Appeal of Community Plan Evaluation 429 Beale Street and 430 Main Street Project Supplementary Response

RE: Board File No. 180697, Planning Department Case No. 2014-002033ENV – Appeal of the Community Plan Evaluation for the 429 Beale Street and 430 Main Street Project. Block/Lot: 3767/305 and 306

Subject: Response to Grassetto Environmental Consulting Review of CEQA Determination for 430 Main Street Project dated July 20, 2018

Figure 1. (left) PM_{2.5} Thresholds and Maximum Project Impact. (right) Cancer Risk Thresholds and Maximum Project Impact.

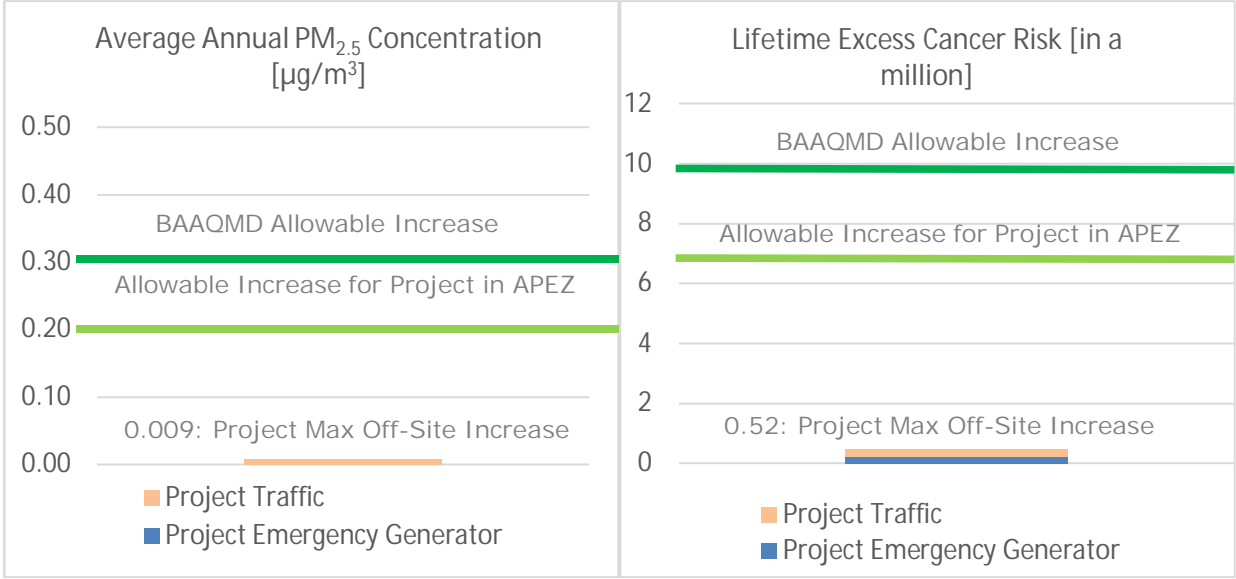
Additionally, GECO incorrectly asserts that health risk impacts to the residences at 201 Harrison Street were not considered.

Analyses were conducted to determine whether the additional impact of the proposed Project emissions to off-site and on-site receptors would exceed these incremental thresholds. As shown in Tables 8 through 11 of the AQTR, the maximum cumulative cancer risk and PM_{2.5} concentrations from traffic plus emergency generator operations were 0.52 in a million and 0.0093 ug/m³, respectively. These maximum impacts are far below the thresholds and are therefore not considered to significantly impact health. Comparisons of the maximum Project impacts to the PM_{2.5} and cancer risk thresholds are shown in Figure 1.

With regards to consideration of health risk impacts to the residents at 201 Harrison Street, these residences were included in the evaluation of potential off-site impacts from Project operations, as shown in Figure 1 above. Further, in the CFD modeling performed (see Figure 2 above), evaluation of the open courtyards is a conservative estimate for any residences that may open windows nearby as reported values assume 100% outdoor exposure. In fact, concentrations indoors would be a fraction of outdoor levels so exposures reported in the AQTR are higher than what someone living at 201 Harrison Street would actually see.

Figure 2. CFD Modeling Results

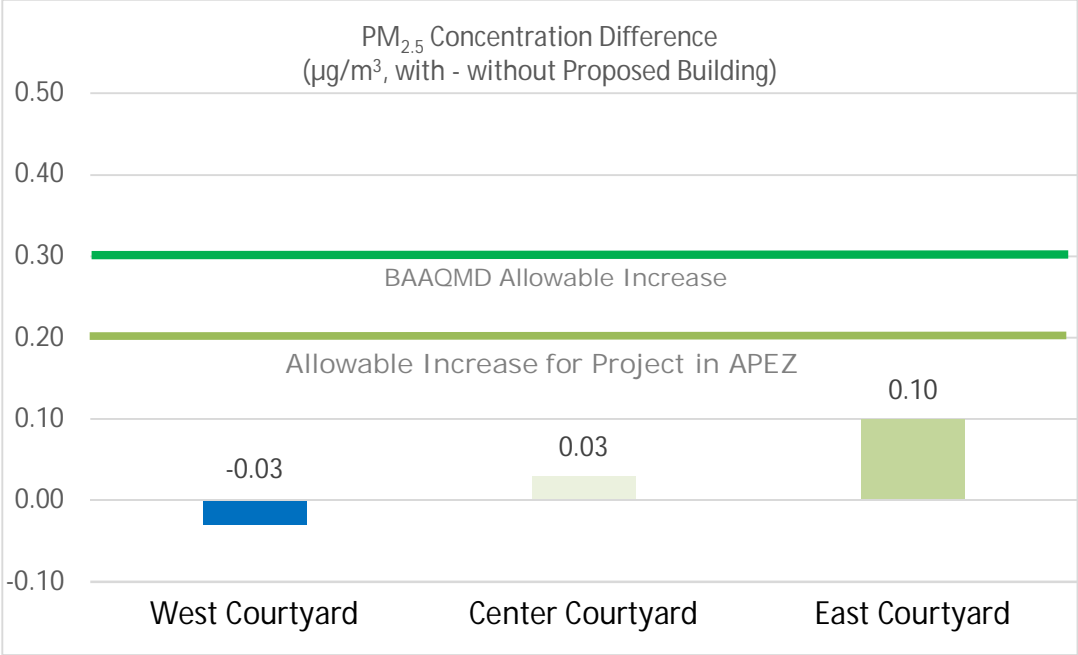
GECO incorrectly asserts that the Project is required to further assess and mitigate its PM_{2.5} emissions and incorrectly asserts how Article 38 should be applied. The Project will not increase pollutant concentrations above the incremental project thresholds and already considers the significance standards relevant to areas with high existing pollutant concentrations.

In order to address specific concerns raised by community members, CFD modeling was performed to further visualize the potential impacts of the proposed building on existing traffic emissions dispersion in response to the 2009 CEQA appeal of a previous project on the project site. As shown in Table 13 of the AQTR, the maximum increase in PM_{2.5} concentration in any of the neighboring courtyards due to

the building placement was 0.1 $\mu\text{g}/\text{m}^3$. This increase would also be well below the threshold of 0.2 $\mu\text{g}/\text{m}^3$, as shown in Figure 2.
